Access Compliance Report

Public Rights-of-Way

(Curb Ramps)

Intersection ID: 10725	Main Street: N_TRYON_ST	Cross Street: KESWICK_AV	Location: NW
ADA ID: C3AD250A322B	Ramp Type: Perp	Initial Pass/Fail: Fail	Overall Compliance: No
Severity Score: 21.25			
Codes/Mitigation Info/Possible Solution		Field Measurements/Component Compliance

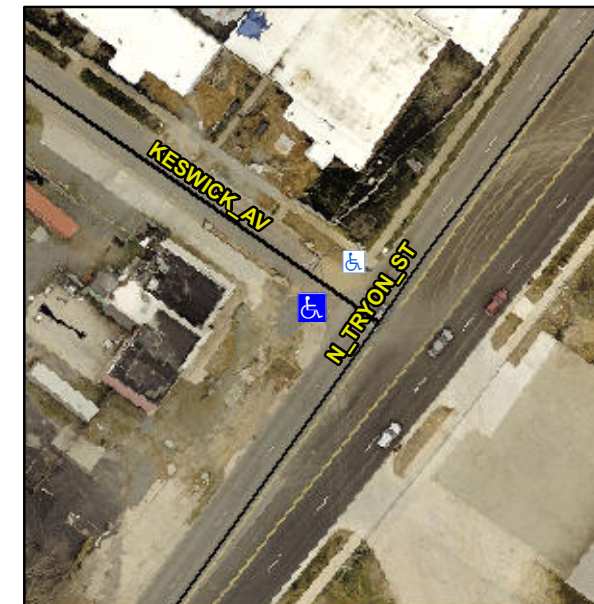
Not Found, R304.5.1, R304.2.2

Compliance	Description	Data	Compliance	Description	Data
N/A	Ramp Length (in)	29.5	No	Ramp Slope (%)	9.9
No	Ramp Width (in)	46.0	Yes	Ramp XSlope (%)	1.6
N/A	Flare Type LT	N/A	N/A	Flare Type RT	N/A
N/A	Flare Slope LT (%)	N/A	N/A	Flare Slope RT (%)	N/A
N/A	Flare Traversable LT?	N/A	N/A	Flare Traversable RT?	N/A
N/A	Landing Length (in)	N/A	N/A	DWS Provided?	N/A
N/A	Landing Width (in)	N/A	N/A	DWS Contrast?	N/A
N/A	Landing Slope (%)	N/A	N/A	DWS Length (in)	N/A
N/A	Landing X Slope (%)	N/A	N/A	DWS Full Width?	N/A
N/A	Landing Curb? (Y/N)	N/A	N/A	DWS Offset (in)	N/A
N/A	Shared Landing?	N/A			
N/A	Gutter Ponding?	N/A	N/A	Gutter Slope (%)	N/A
N/A	Gutter Lip Ht (in)	N/A	N/A	Gutter X Slope (%)	N/A
N/A	Painted X Walk1?	No	N/A	Painted X Walk2?	N/A
	X Walk 1 Direction	To NE		X Walk 2 Direction	N/A
N/A	X Walk 1 Width (in)	N/A	N/A	X Walk 2 Width (in)	N/A
	X Walk 1 Slope (%)	1.8		X Walk 2 Slope (%)	N/A
	X Walk 1 X Slope (%)	0.1		X Walk 2 X Slope (%)	N/A

Remove & Replace Entire Ramp.
